ADDENDUM NUMBER 02

**ARPA- CAMPGROUND EXPANSION PROJECTS
A FEDERAL AID PROJECT**

PAWTUCKAWAY STATE PARK

DIVISION OF PUBLIC WORKS PROJECT NUMBER 81205R

A3.01
REVISED

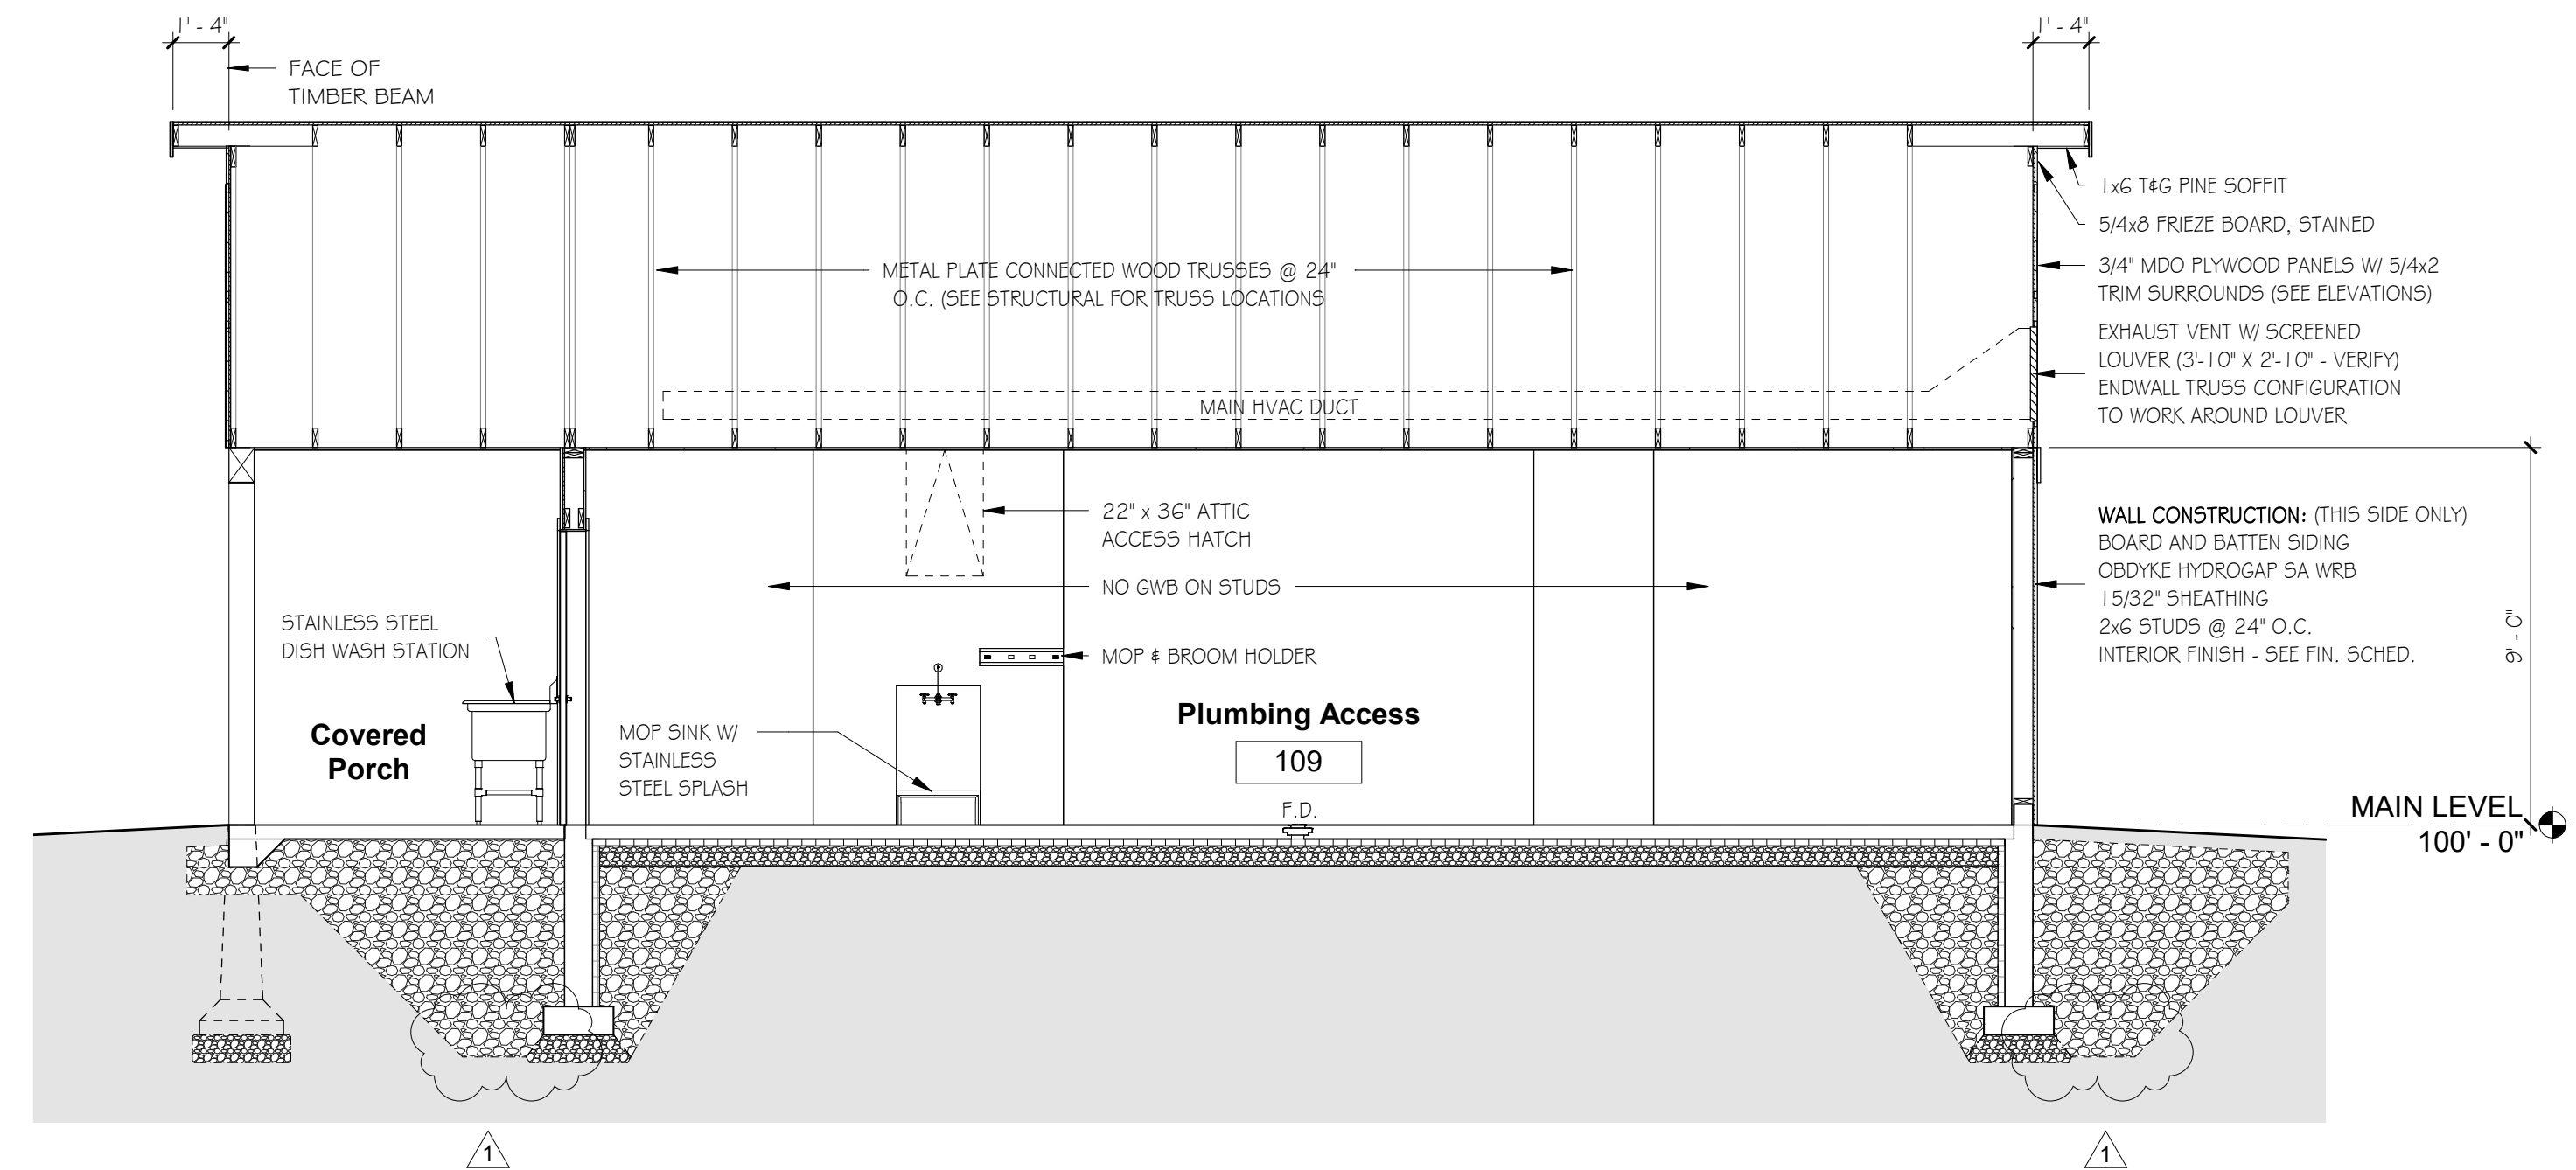
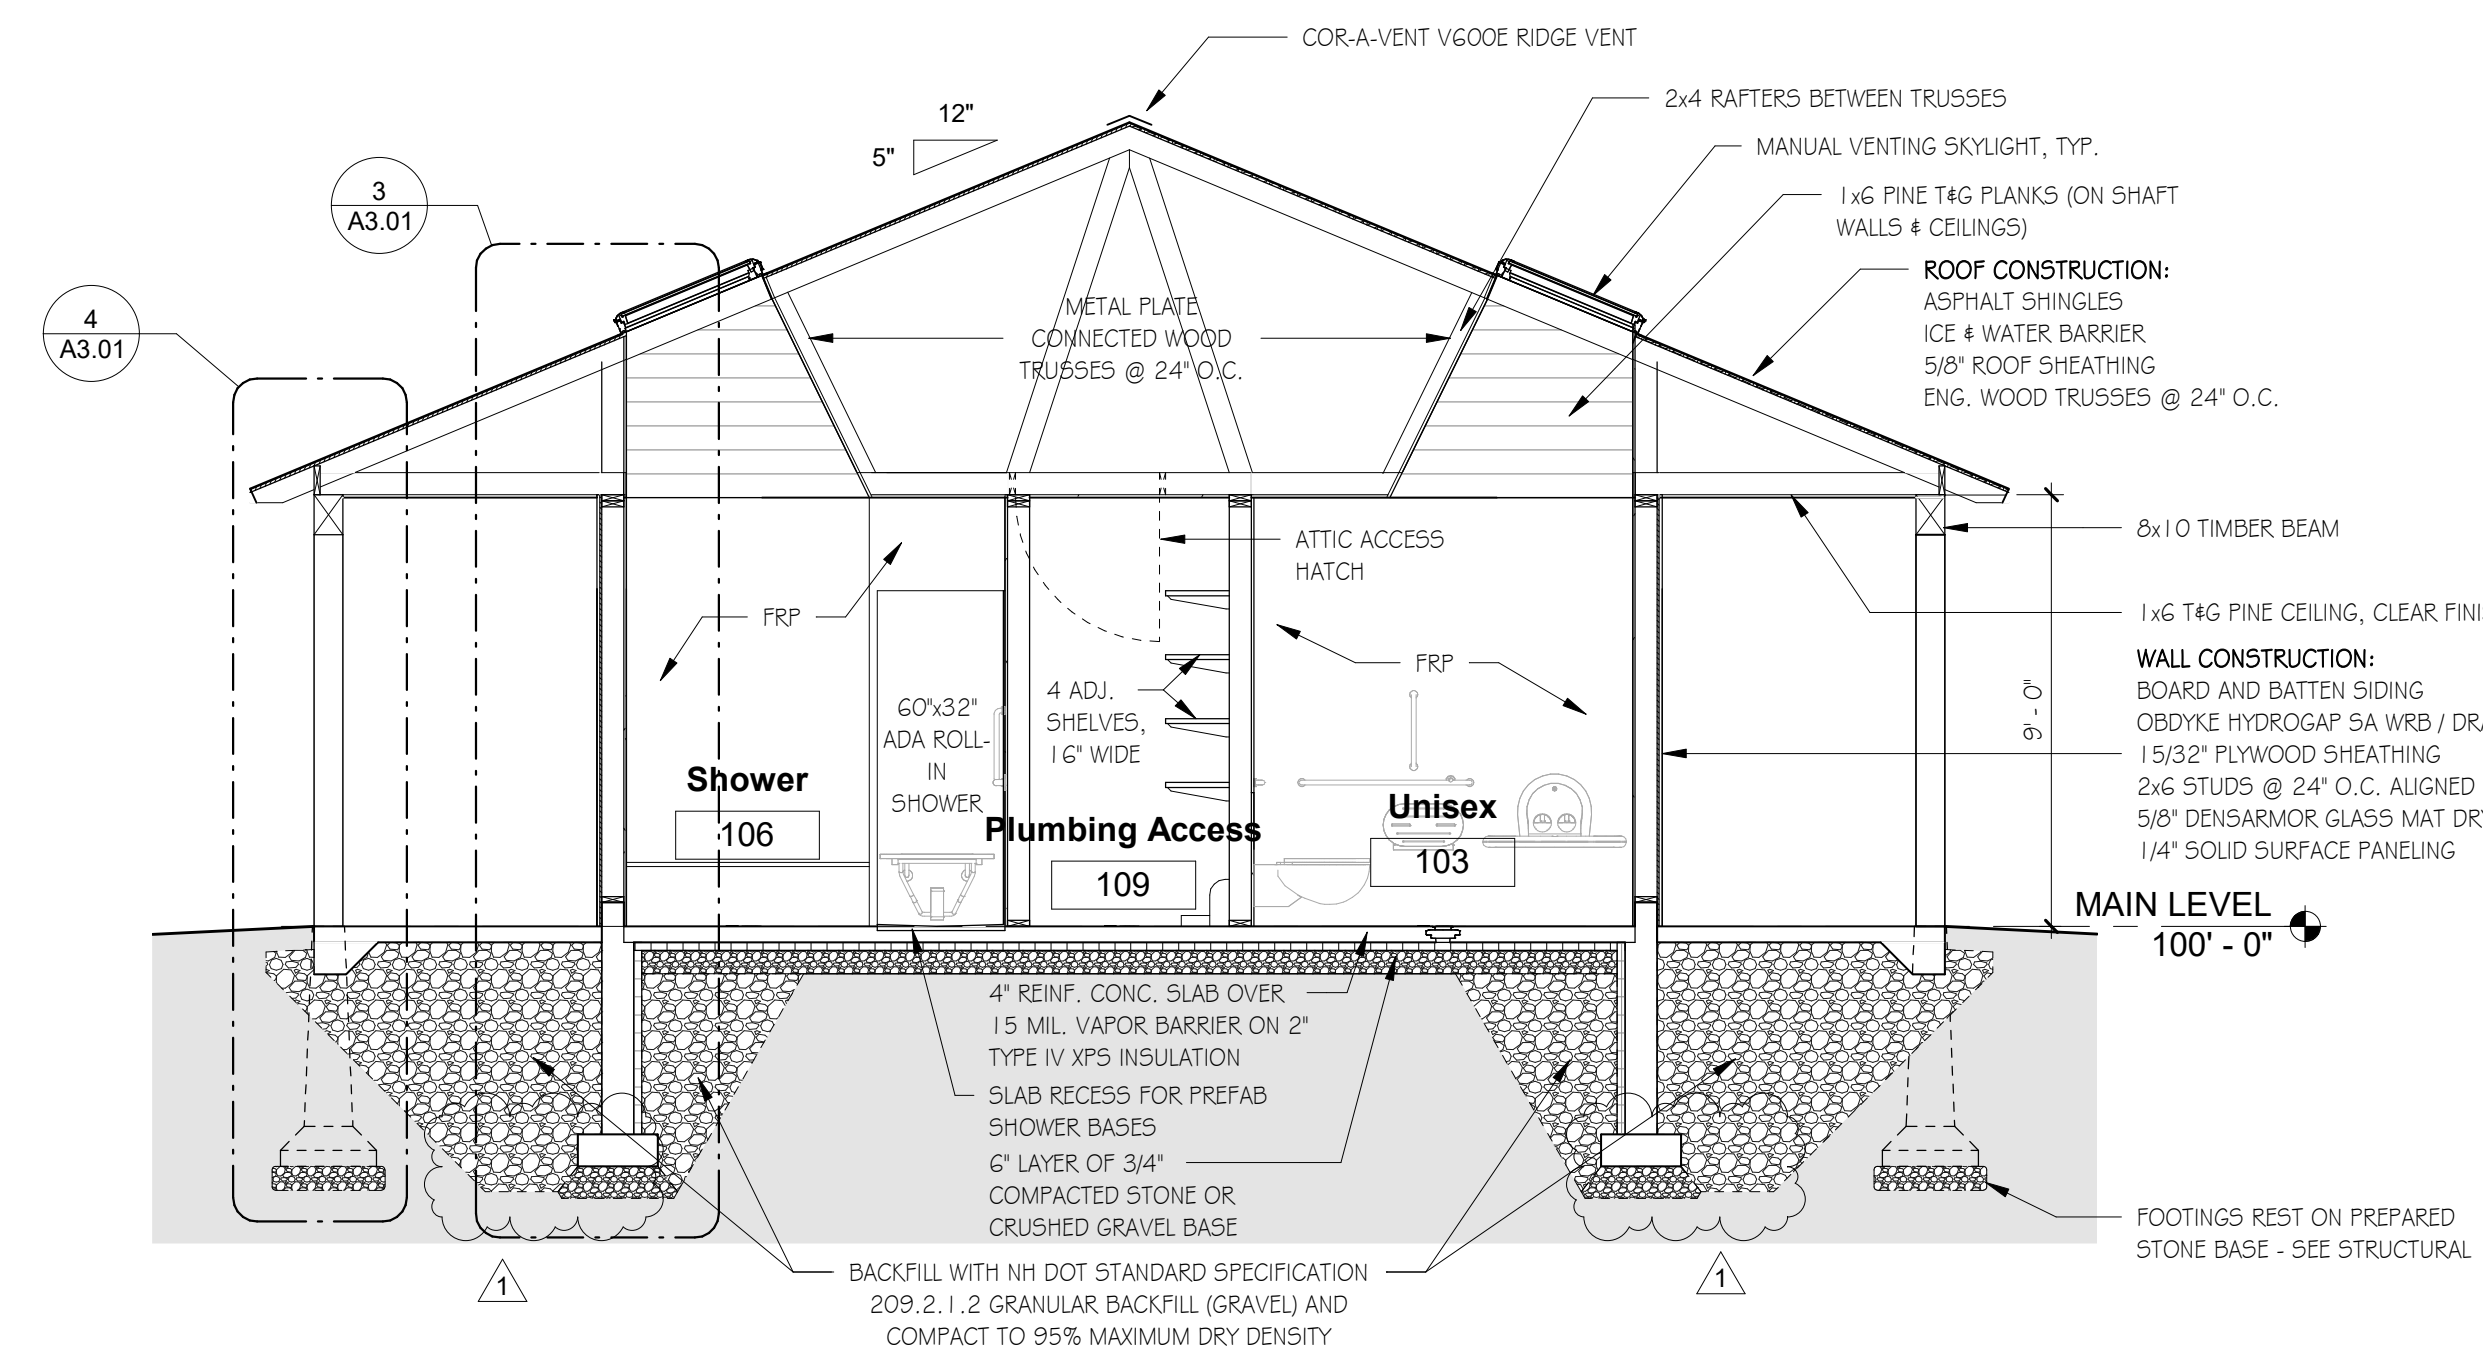
8. Deleted foundation drain.

Response: *Foundation underdrains are not required. See revised sheets A3.01 and S1.01.*
40. Question: Specification 310519.16 Geomembrane Liners. Where is this specification applicable? I do not see any areas noted for geomembrane liners.
